# **Safety Evaluation Report** for the Dewey-Burdock Project Fall River and Custer Counties, South Dakota

**Materials License No. SUA-1600**

Docket No. 40-9075  
Powertech (USA) Inc.

**March 2013**

Figure 1. Comparison of the Reported Drawdown and Drawdown from the modeling Software

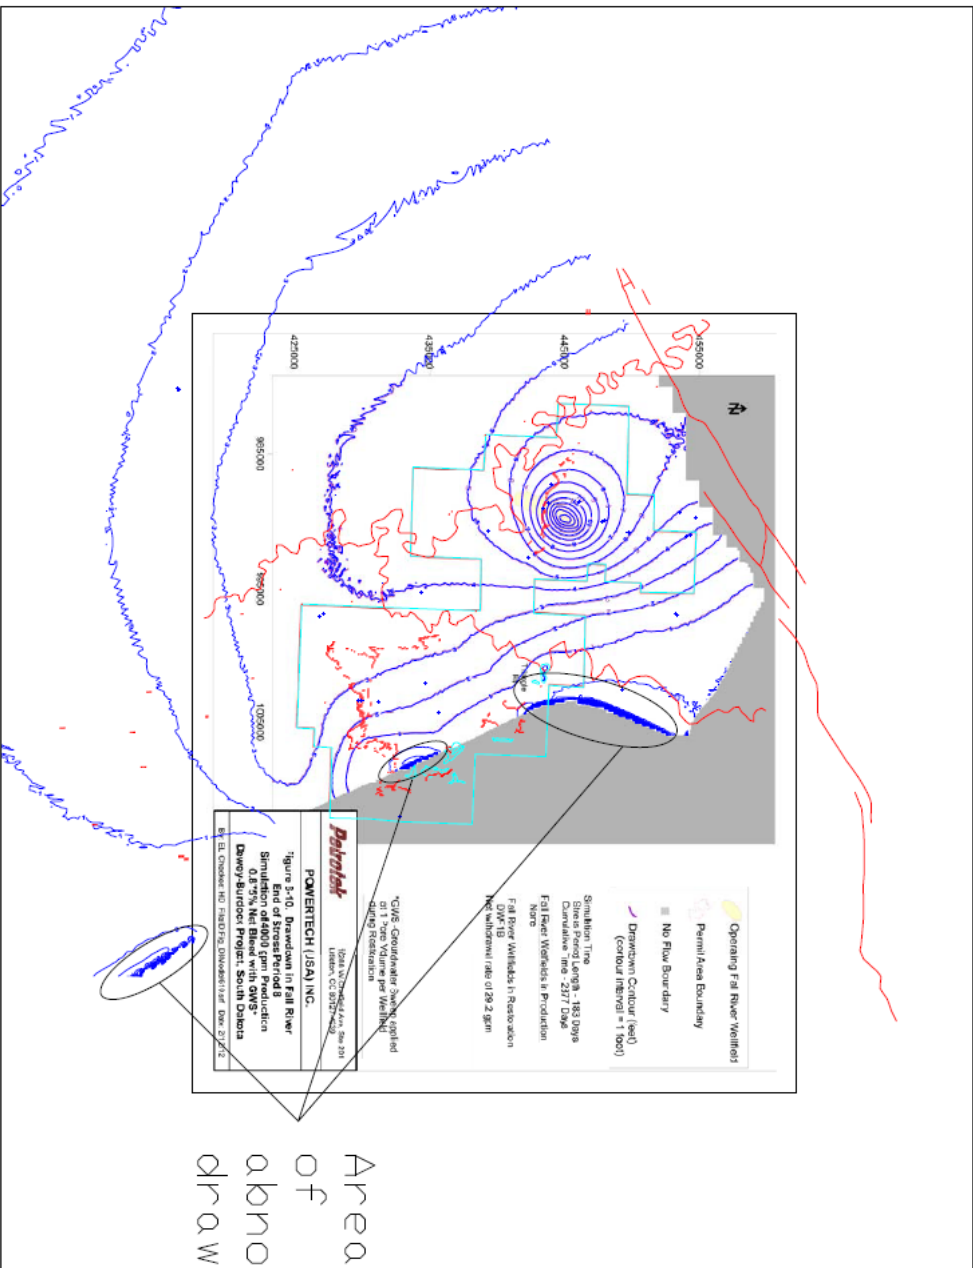
Staff reviewed the model geometry, hydraulic properties and parameters and locations of the boundaries. Several minor discrepancies were noted between the electronic files and the report (Table 1). In general, the discrepancies represent minor errors and are common for complex models. Most of the discrepancies would not appreciably impact the model predictions; however, staff was concerned about the abnormal drawdown adjacent to the GHB conditions (Figure 1). The abnormal drawdown may be attributed to discrepancies noted in the recharge, storativity or GHBs (see Table 1), or, conflicts with the starting head file.<sup>1</sup>

Area  
 of  
 abnormal  
 drawdown

Figure 2. Corrected Model predicted drawdown in the Chilson Member

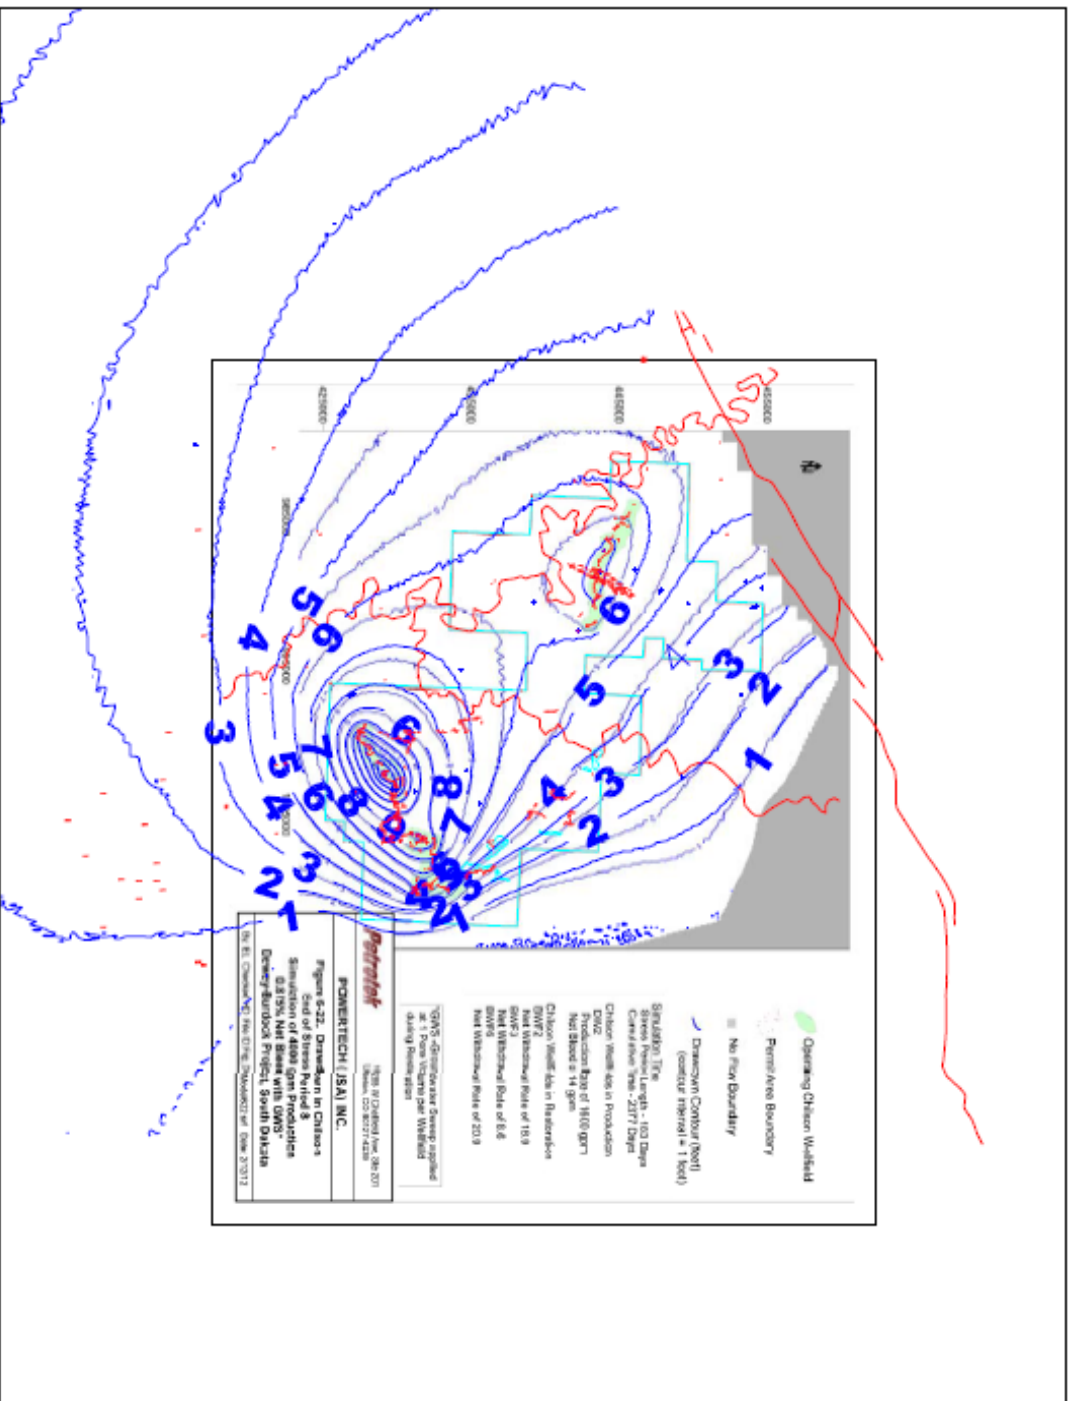
Staff corrected the model for discrepancies in recharge, storativity and GHBs, and established starting heads for the predictive simulation using the output from the steady-state calibration simulation. Correcting the model affected the predicted drawdowns in the Fall River Formation and Chilson Member, as shown in Figure 2 and Figure 3, respectively. The effect of the corrected model on the Fall River Formation model-predicted drawdown is to increase the drawdown by approximately 1 foot. The effect on the Chilson Member model-predicted drawdown is less than that for the Fall River Formation.
